**Operator: 8 North**

**Location Name: BASHOR PC GQ 15-13**

**Loc ID: 417826**

**Inspection: 684904669**

**Exhibit C**

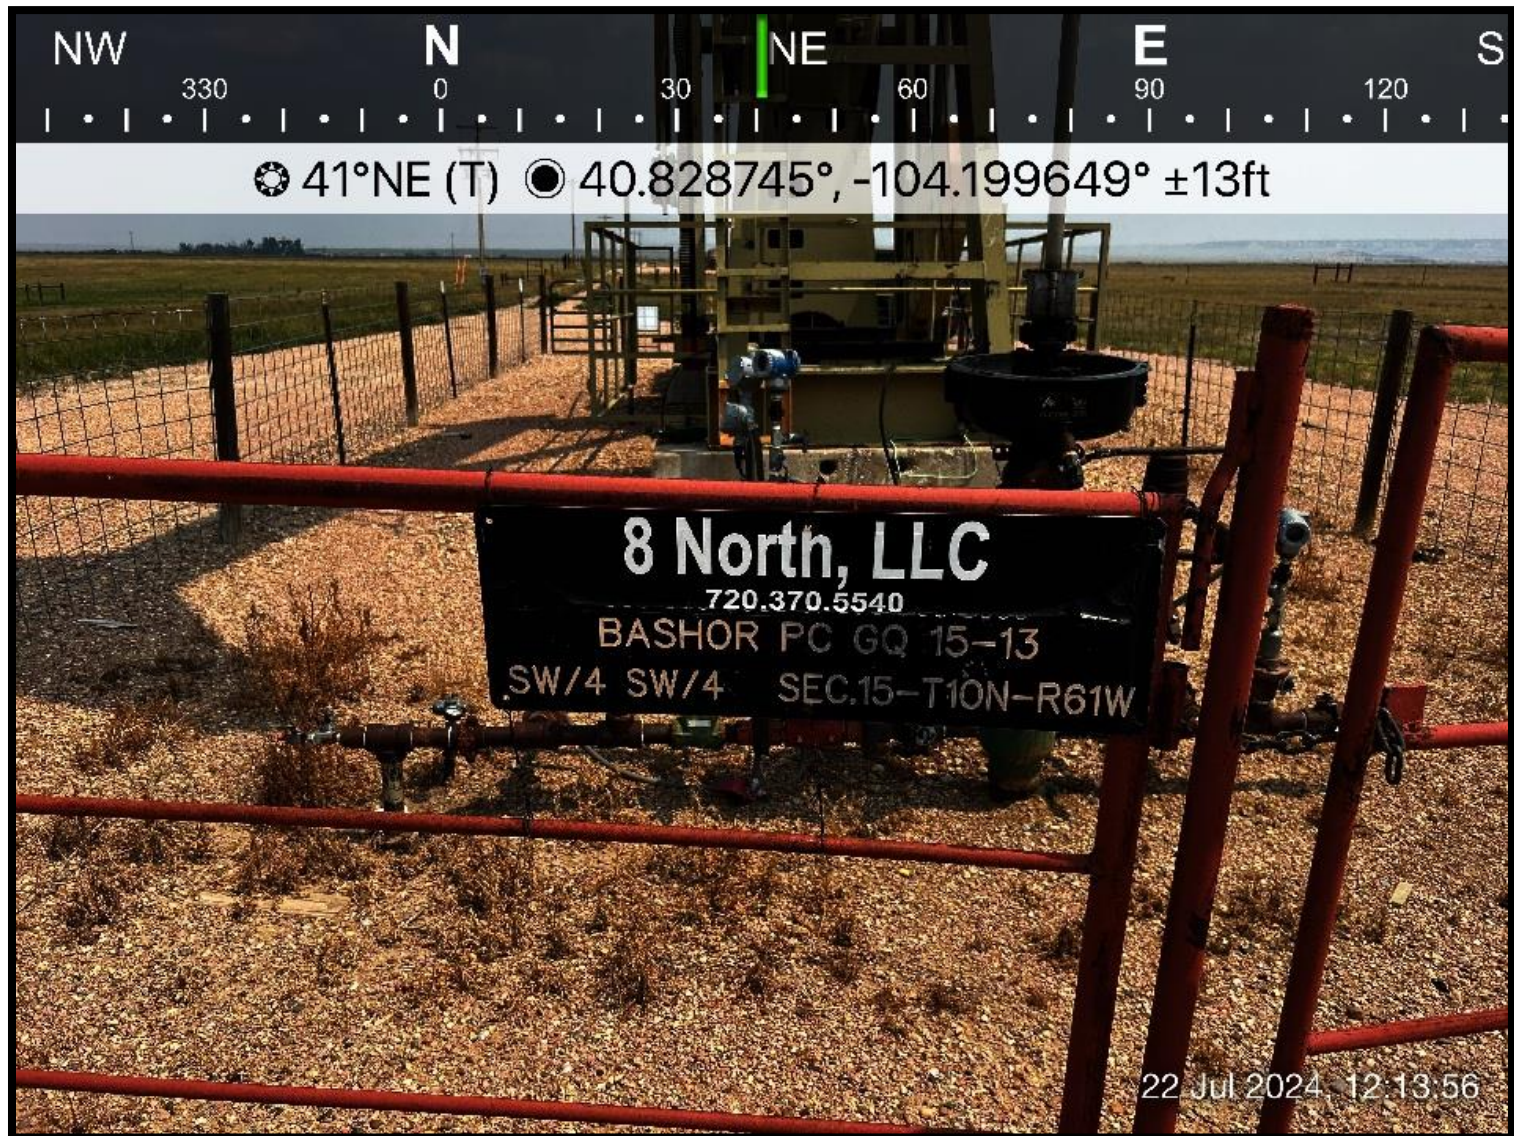
**CA:** Stained soil at wellhead Corrective Action: Remove or remediate stained soil; Securely fasten all valves, pipes, and fittings to ensure good mechanical condition, inspect at regular intervals and maintain in good mechanical condition per Rule 605.d.

**CA Resolution:** Operator has provided photo evidence to show that the stained soil has been appropriately removed/cleared and mechanical issues leading to the leak have also been addressed.

Exhibit A

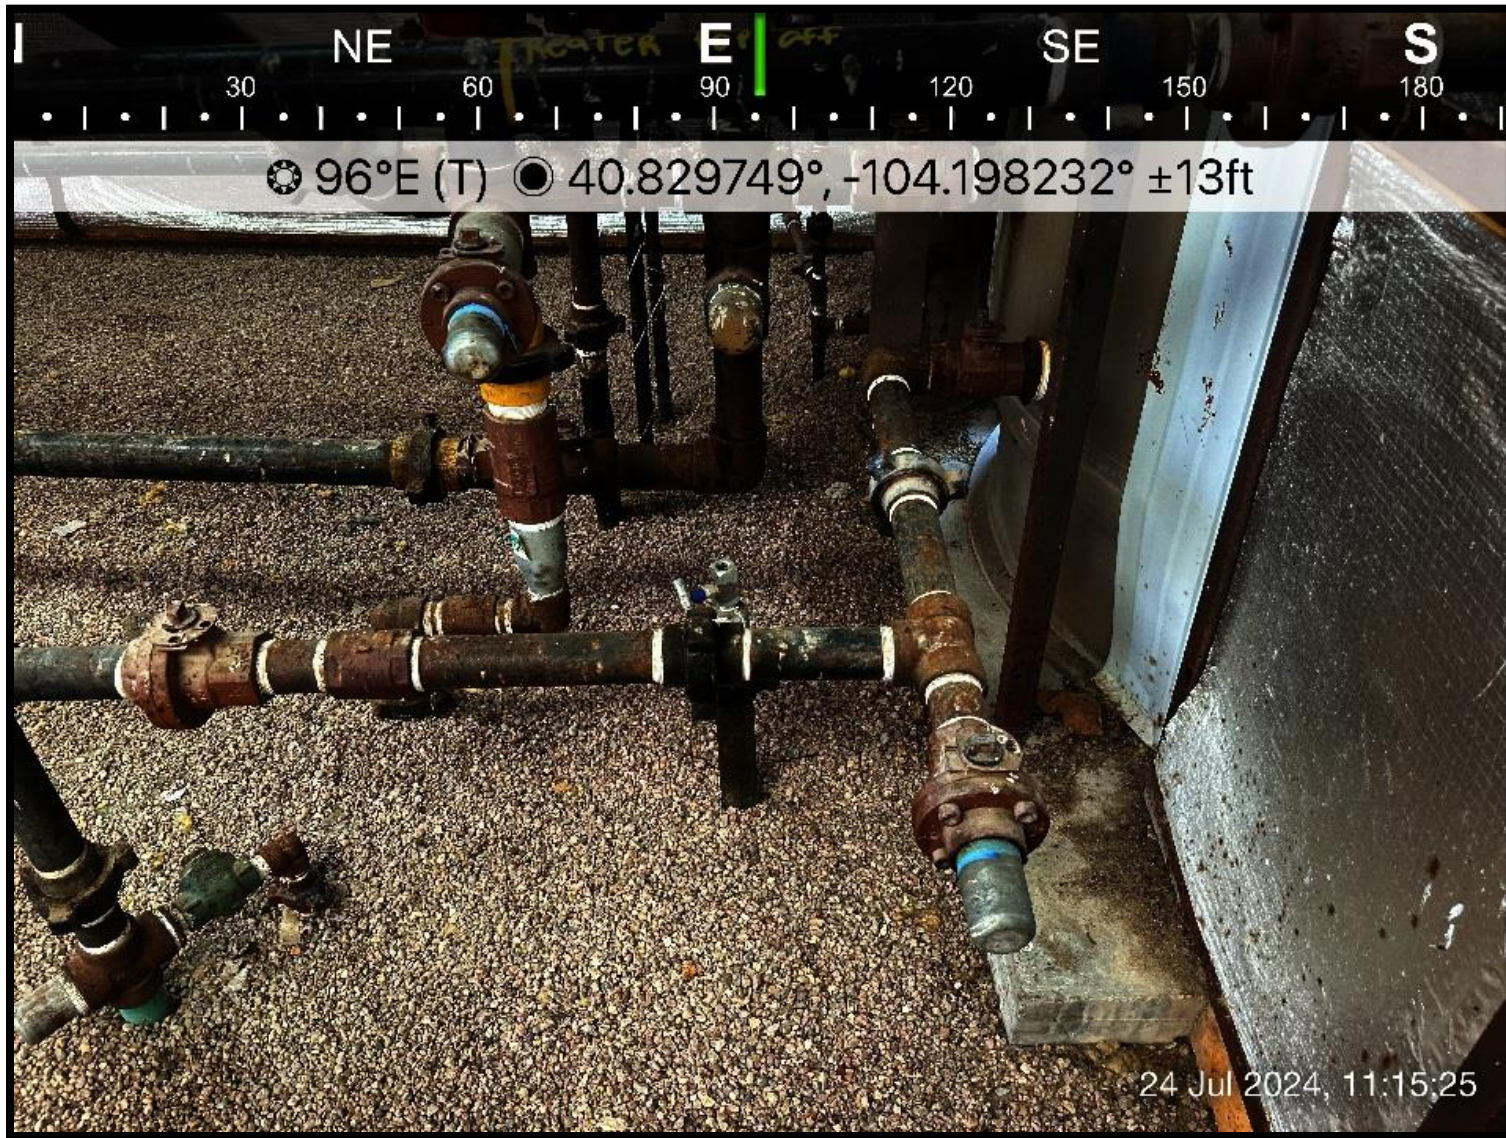
**CA:** Stained soil in treater house Corrective Action: Remove or remediate stained soil; Securely fasten all valves, pipes, and fittings to ensure good mechanical condition, inspect at regular intervals and maintain in good mechanical condition per Rule 605.d.

**CA Resolution:** Operator has provided photo evidence to show that the stained soil in treater house has been appropriately removed/cleared and mechanical issues leading to the leak have also been addressed.
